Subject: Facility ID: 39859-Citrus County Central Landfill: Response to Warning Letter #WL19-107SW09SWD

RE: Citrus County Central Class I Landfill

Facility ID#: 39859

Warning Letter #WL19-107SW09SWD

Figure 5: Photos of new well pads on MW-19 and MW-19D

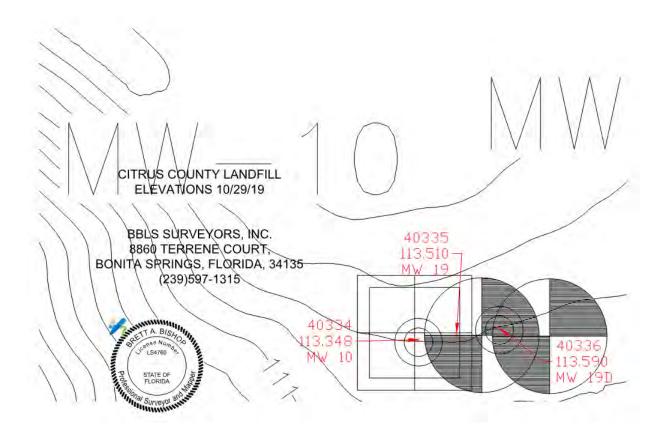
Comment 2.37: Explanation: Well pads for MW-19 and MW-19D were cracked. Appendix 3.IV of the Permit requires notification if a well becomes damaged or inoperable.

Corrective Action: In an email dated October 18, 2019, Henry Norris stated "MW-19 and MW-19d were found to be damaged by contractor installing powered gas extraction system on the 7 acre site. Field services workers from Jones Edmunds have inspected the wells and found that the integrity of the wells have not been compromised and informed the contractor of the required repairs to concrete pads. Will follow up with FDEP when concrete work is complete." Please provide an expected timeline for these repairs and report submittal. Not every well was inspected during the inspection by the Department. The Department recommends that Citrus County verify that each well is intact, locked, labelled, and properly maintained.

Response 2.37: Jones Edmunds inspected the wells and determined that they were not damaged, just the pad was cracked. The Contractor who damaged the wells has replaced the pads and the new pads are shown in Figure 5. The well top of casings (TOCs)
